Re: Application # 2014/3668/P & 2014/2893/PRE

I wish to register my objection to the above applications. My grounds for my objection are that, living at the above address, my property is approximately 10 yards from the boundary fence of the projected construction in the back garden of #31 Briardale Gardens and believe I will be adversely affected if the proposed plan is undertaken.

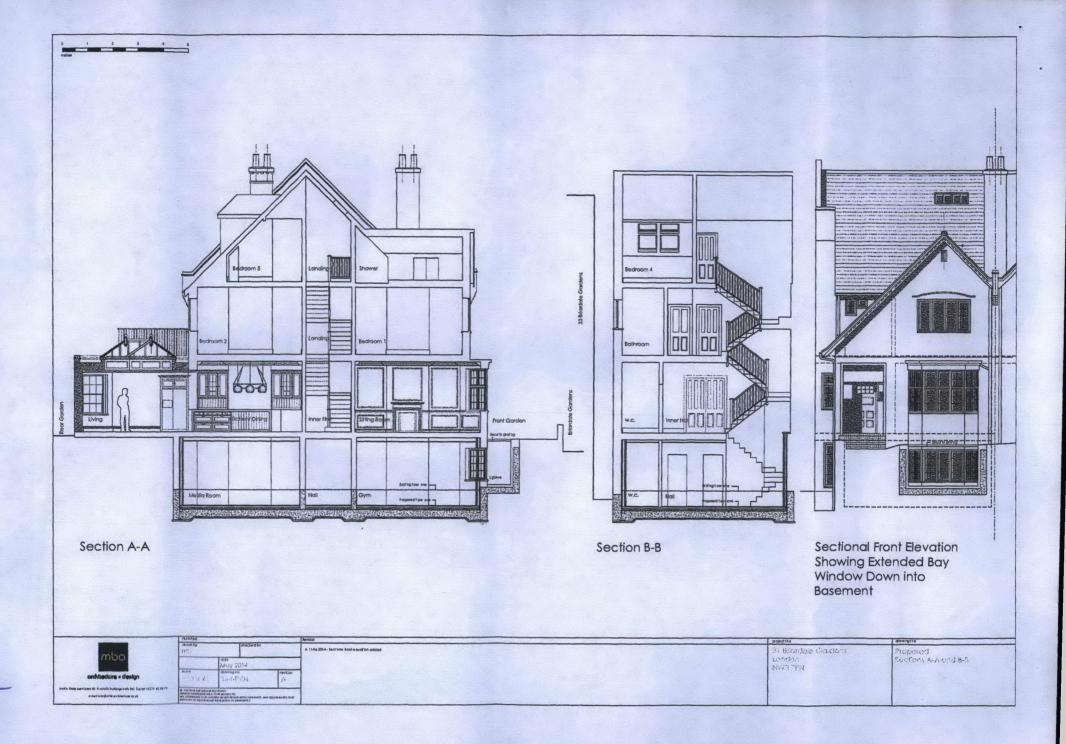
Moreover, there is hydrological concern based on the existence of a buried culvert running through their garden and down the easement behind my house (please see the attached map). There is also believed to be an old well (Blackett's Well) in the near vicinity.

om bedoon form stained g a fan ight above front door new bosement foor eve Side Elevation Rear Elevation Front Elevation 31 Briardale Gardens London NW3 7PN Proposed Elevations | date | May 2014 | scoe | drawing no. | 1:50 28 A | 3:64-P-03

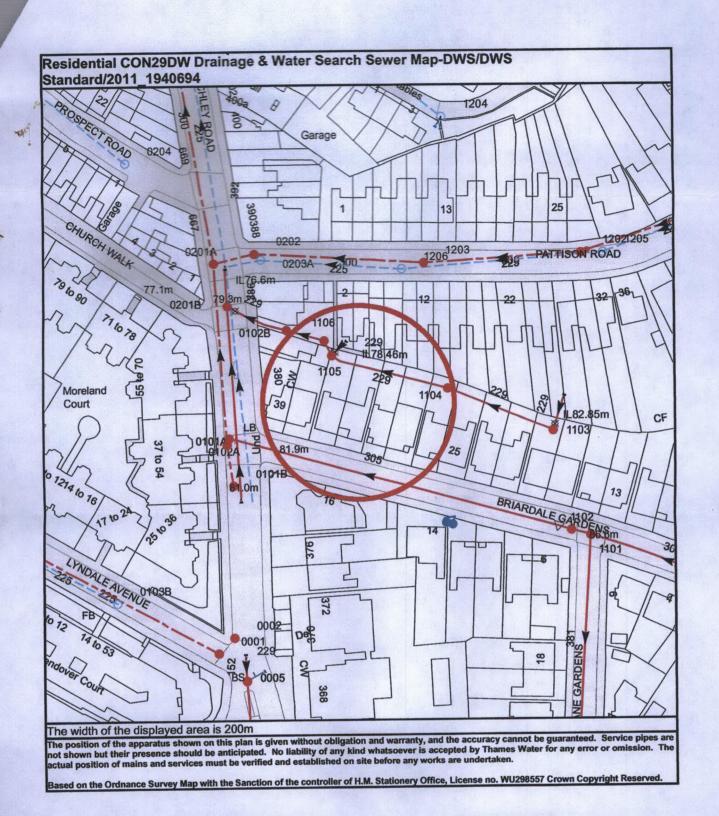
My further objections to the plan are that I not only consider the height and size of the extension to be inappropriate to the Arts & Crafts style of the street and adjacent streets but feel it sets an alarming precedence in terms of *density*, since the gardens are part and parcel of the ambiance of these streets.

I also feel that such large, lantern lights will create additional light disturbance from a room which I understand will be a reception room and therefore visible from our attic bedroom all year around, despite the trees, which currently create a visual barrier (but only when in leaf) between my house and houses in Briardale Gardens.
